From: [REDACTED]
Sent: 31/08/2023 4:00:39 PM
To: Council Northernbeaches Mailbox
Cc: malcolm white
Subject: TRIMMED: DA 2023 0894 18 ROCK BATH ROAD PALM BEACH WRITTEN SUBMISSION: LETTER OF OBJECTION SUBMISSION: TULLOCH
Attachments: 18RBR AUGUST SUBMISSION.pdf; Rock Bath Rd VP1 Ground Level Living Area-Photomontage.pdf; Rock Bath Rd VP2 Upper Level Balcony-Photomontage.pdf; Rock Bath Rd VP3 Lower Garden POS-Photomontage.pdf;

SUBMISSION

RE: DA 2023 0894
18 ROCK BATH ROAD PALM BEACH
WRITTEN SUBMISSION: LETTER OF OBJECTION
SUBMISSION: TULLOCH

EXISTING & PROPOSED (Wire Frame) VP 1

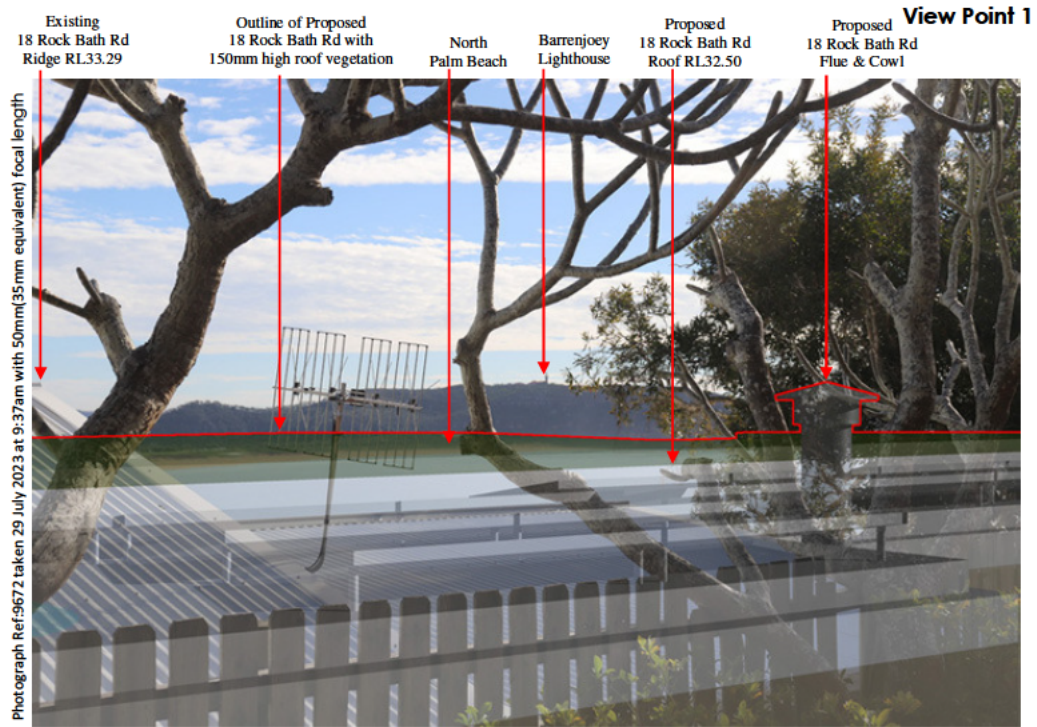
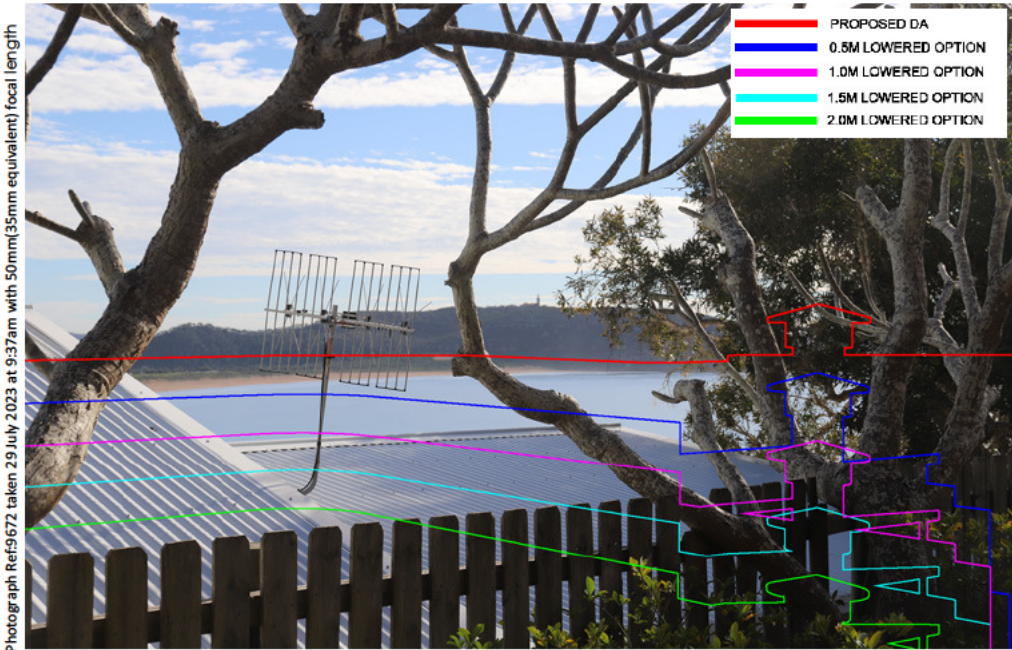
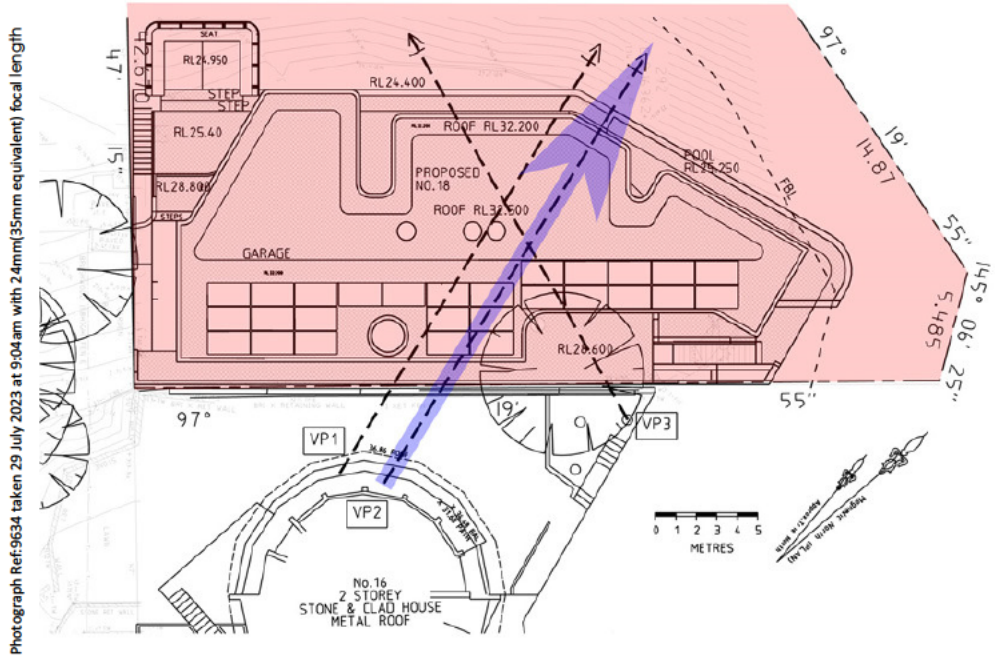
- **VIEWPOINT 1:** zones adjacent the Living Room window at Ground Floor as a **devastating** loss. The view loss will be 100% of the near water view, 100% of the beach, 100% of the beach/surf interface, 100% of the surf zone, and part of the headland. From this viewpoint, the built form would need to be lowered **1.0m** to better protect the view.
- **VIEWPOINT 2:** Entertainment Deck at First Floor, immediately in front of main living/dining/kitchen zones as a **severe** loss. The view loss will be an expansive zone of the near water view, and the surf zone to the southern end of the beach. The loss is increased to severe, as the view from within the main internal spaces would take out more of the beach zone. This can be better

assessed when height poles are erected. From this viewpoint, the built form would need to be lowered **1.0m to 1.5m** to better protect the view.

EXISTING & PROPOSED (Wire Frame) VP 2

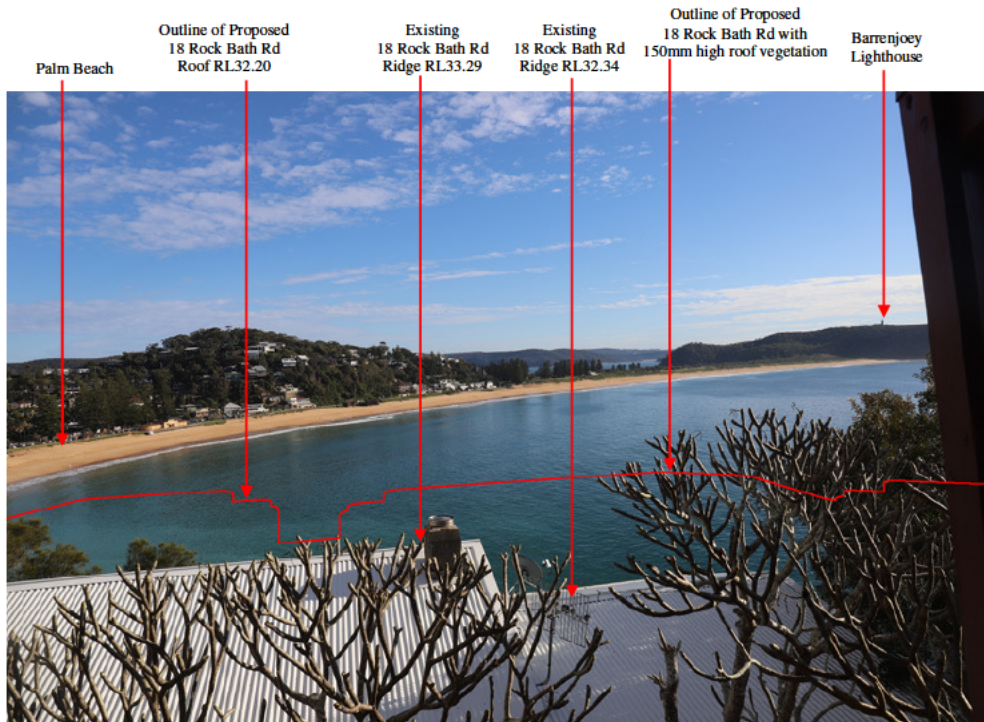
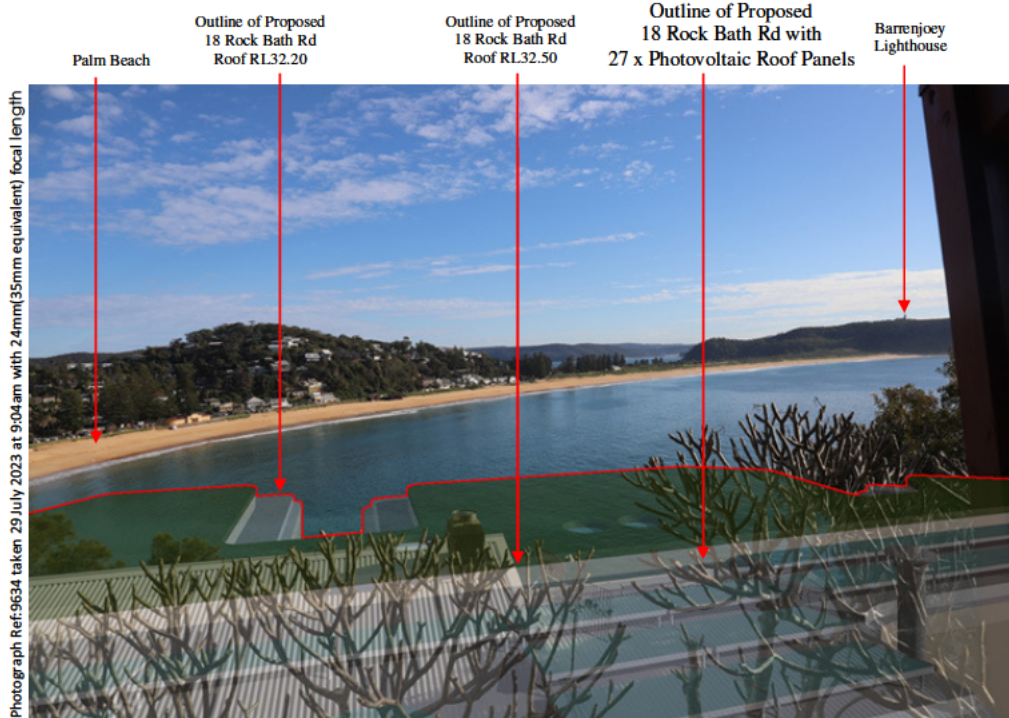
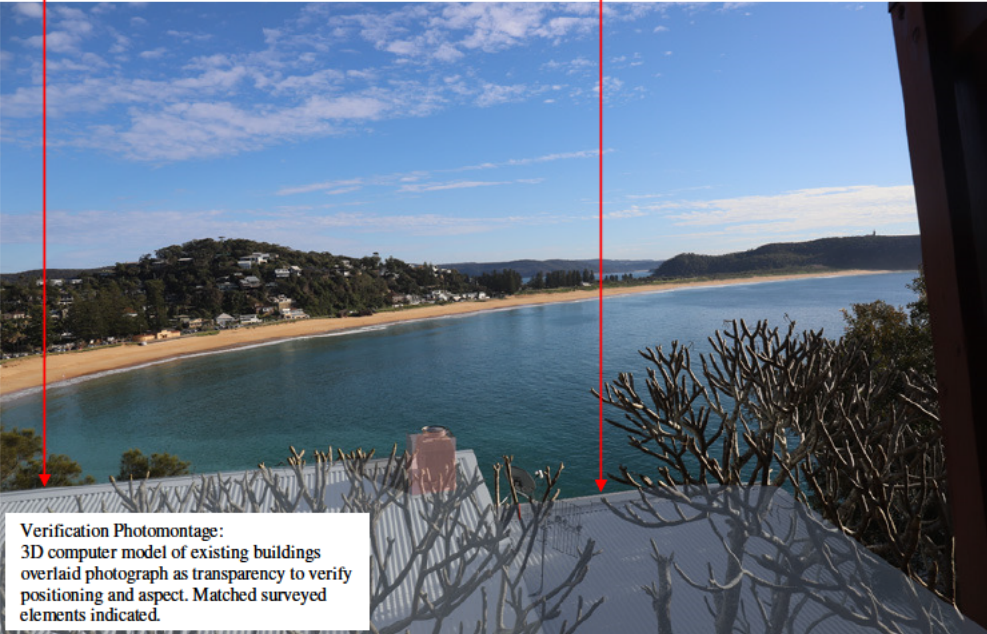
- **VIEWPOINT 1:** Living Room window at Ground Floor
- **VIEWPOINT 2:** Entertainment Deck at First Floor, immediately in front of main living/dining/kitchen zones;
- **VIEWPOINT 3:** Vantage Point within private open space

Pam Walls photomontages confirms my initial assessment that considering STEP 3: EXTENT OF IMPACT, that the composite view loss from my clients' property is moderate or above.

EXISTING & PROPOSED & MORE SKILFUL DESIGN VP 3

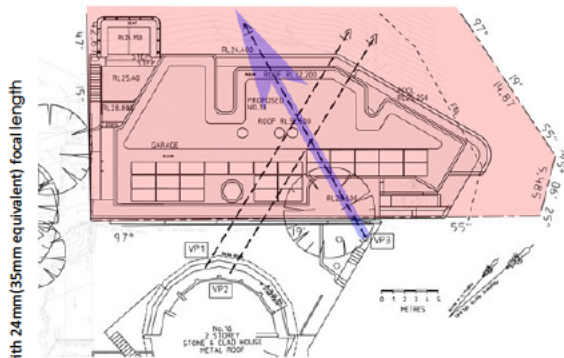
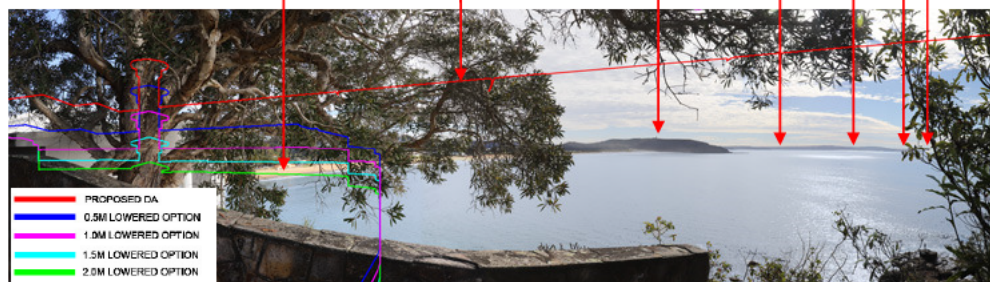
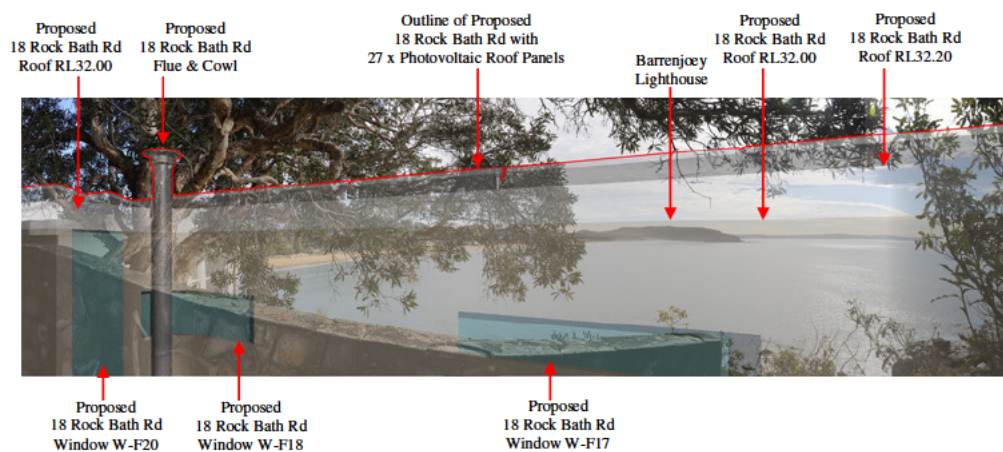
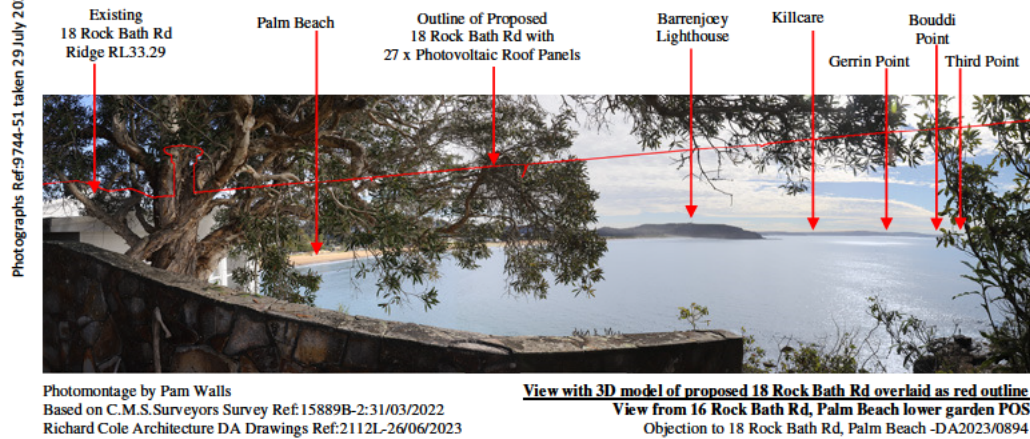
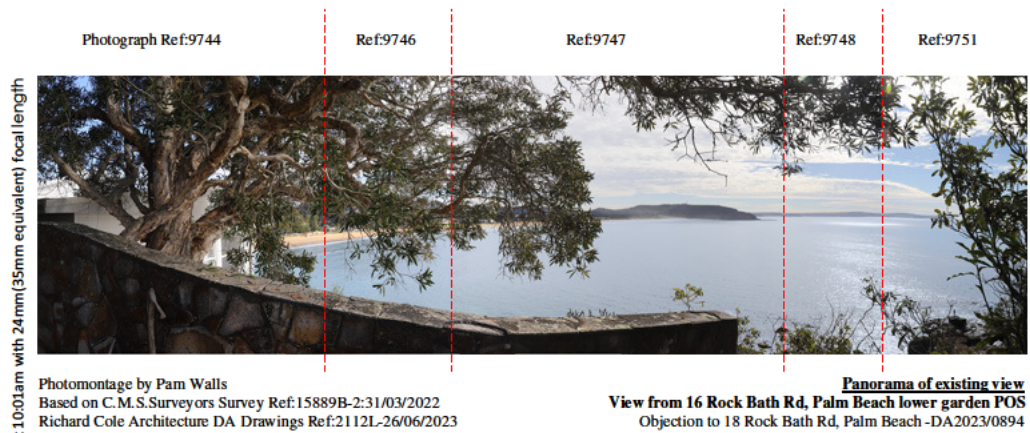
- **VIEWPOINT 3:** Vantage Point within Private Open Space as a **devastating** loss. The view loss will be 100% of the near water view, 100% of Palm Beach view, 100% of the water/land interface view, 100% of the surf zone view, the near rock shelf east of the Palm Beach Ocean Pool, 100% of Barrenjoey Headland, all of Barrenjoey Lighthouse, and the longer distant view over into Broken Bay, and beyond to the Central Coast headland views. If the viewpoint rotated to the left, there is also an expansive view of the beach zones towards Kiddies Corner at Palm Beach that will also be completely lost. From this viewpoint, the built form would need to be substantially altered by **deleting the eastern wing**, and the **built form lowered 1.0m to 1.5m** to better protect the view.

**More Skilful Design Options
View Point 3**

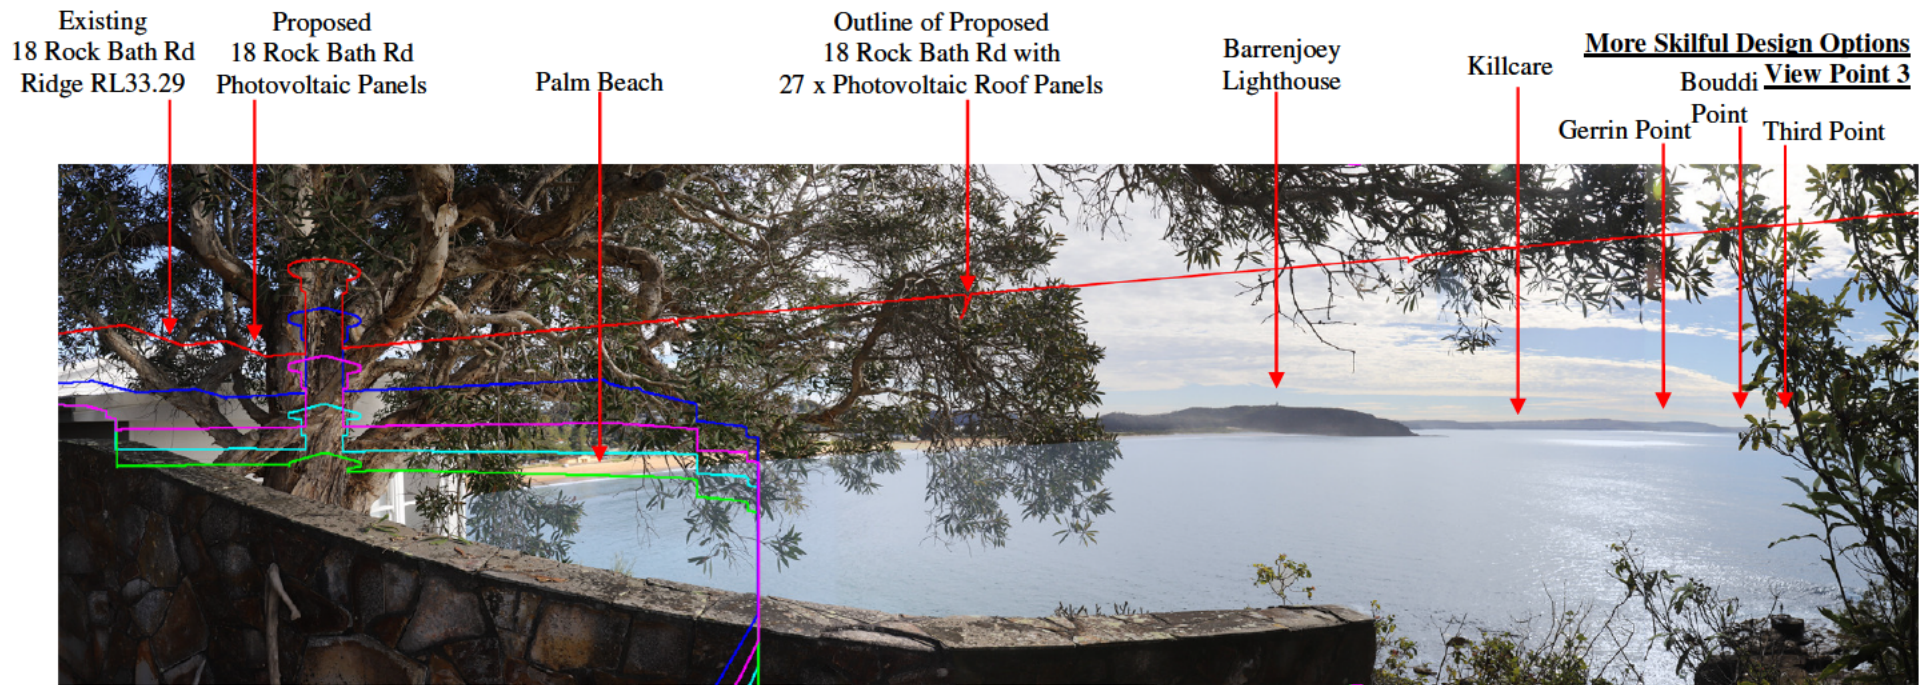
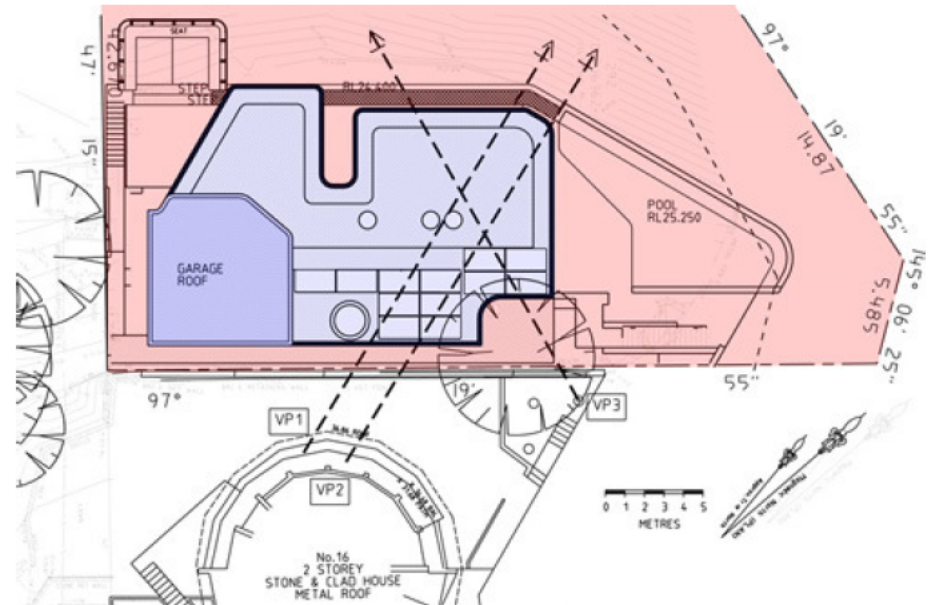
I consider that there is a more skilful design available to the applicant *that 'could provide the applicant with the same development potential and amenity and reduce the impact on the views of neighbours':*

- **Maintain the envelope of the garage**, maintaining the location, assuming pedestrian access from the garage to be immediately adjacent the front door entry, so as not to add any additional built form that may cause additional view loss;
- **Lower the built form by 1.5m:** including the lift and stairs;
- **Delete the upper level of the eastern wing** of the proposed development

- PROPOSED DA
- 0.5M LOWERED OPTION
- 1.0M LOWERED OPTION
- 1.5M LOWERED OPTION
- 2.0M LOWERED OPTION
